**PITTSBURG UNIFIED SCHOOL DISTRICT
HILLVIEW JUNIOR HIGH SCHOOL
TRACK & FIELD MODERNIZATION PROJECT**

**BID ADDENDUM NO. 1
June 29, 2026**

PROJECT: Hillview Junior High School – Track & Field Modernization Project
333 Yosemite Dr, Pittsburg, CA 94565

DRAWING TITLE: CONSTRUCTION STAGING PLAN
REFERENCE DRAWING: T1
ISSUED VIA: ADDENDUM 01 (6/29/26)
SCALE: N.T.S.

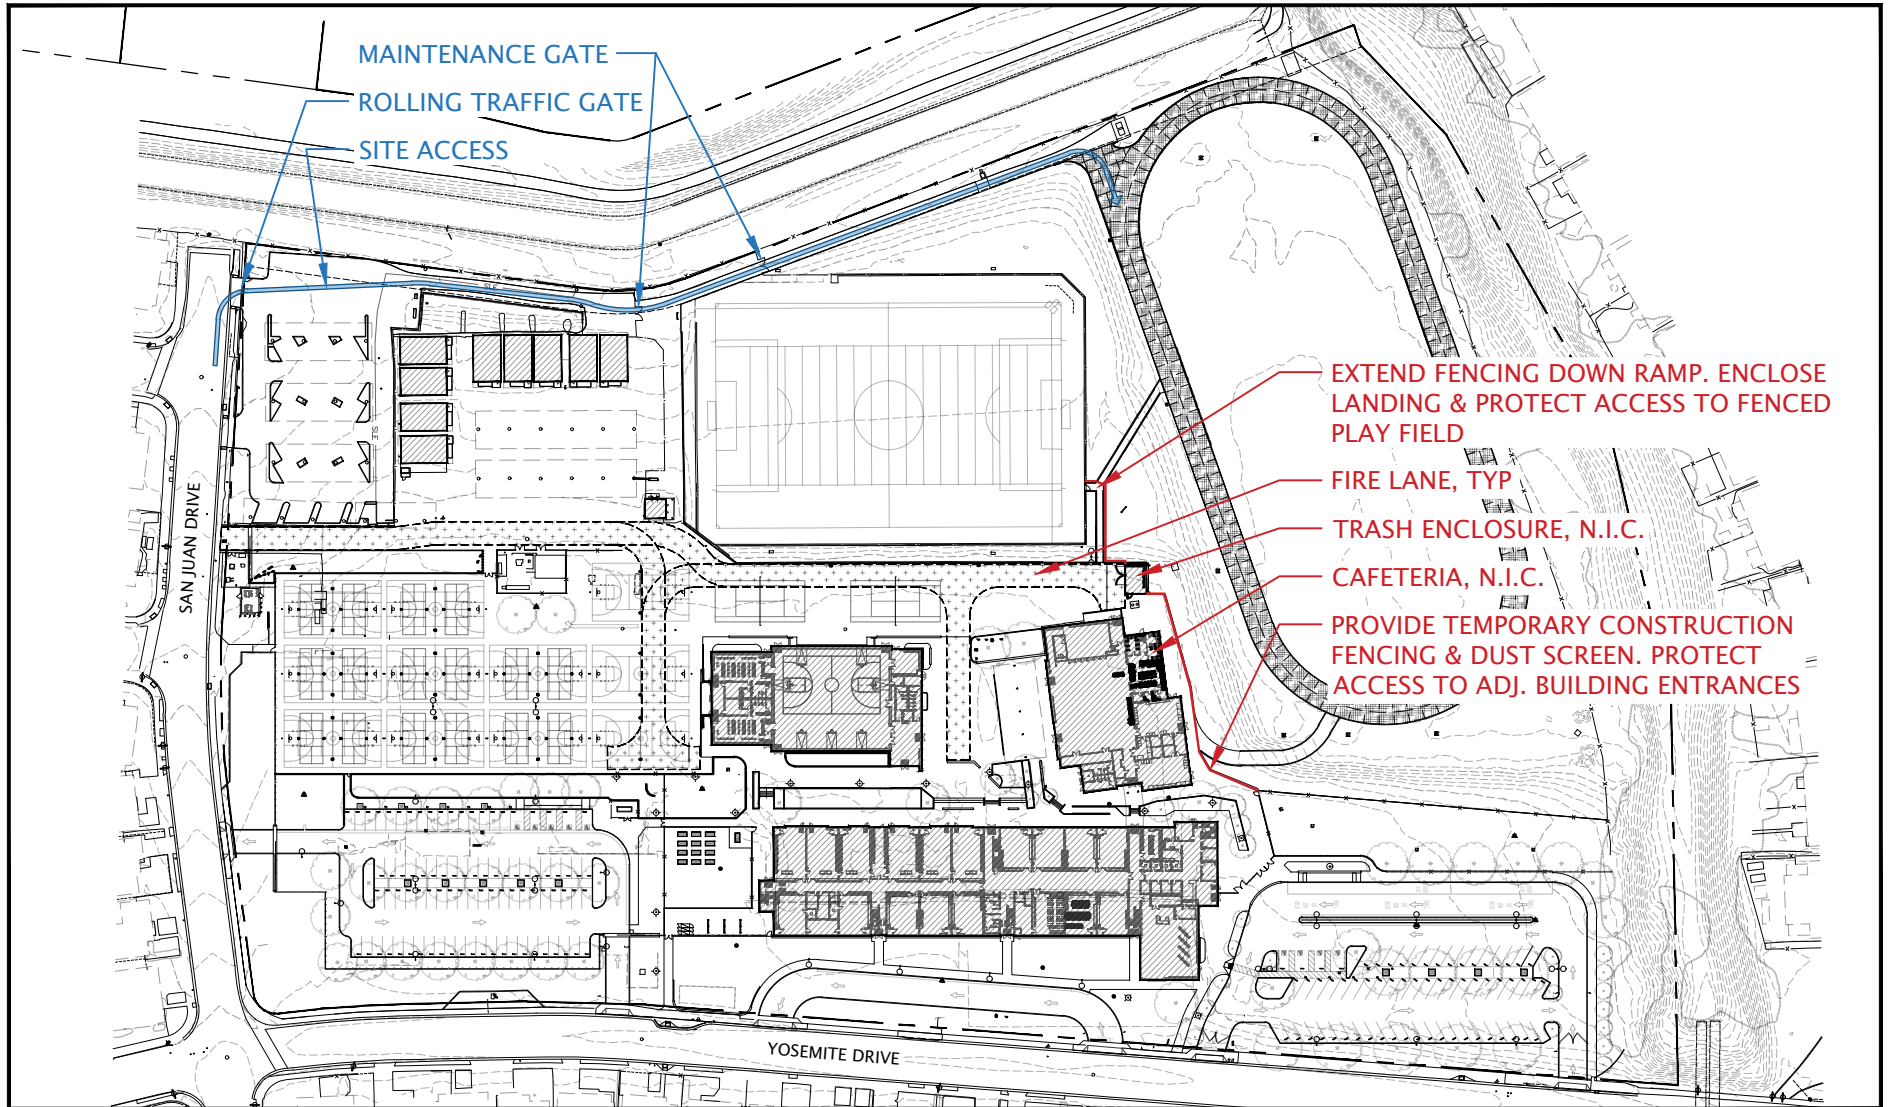
Reference: DOCUMENT 00 21 13 – **INSTRUCTIONS TO BIDDERS**
Attachment: ASK-01: Construction Staging Plan
Description: Contractor shall provide temporary construction fencing and wind screening per attached ASK-01.
Please refer to ASK-01 for site access.
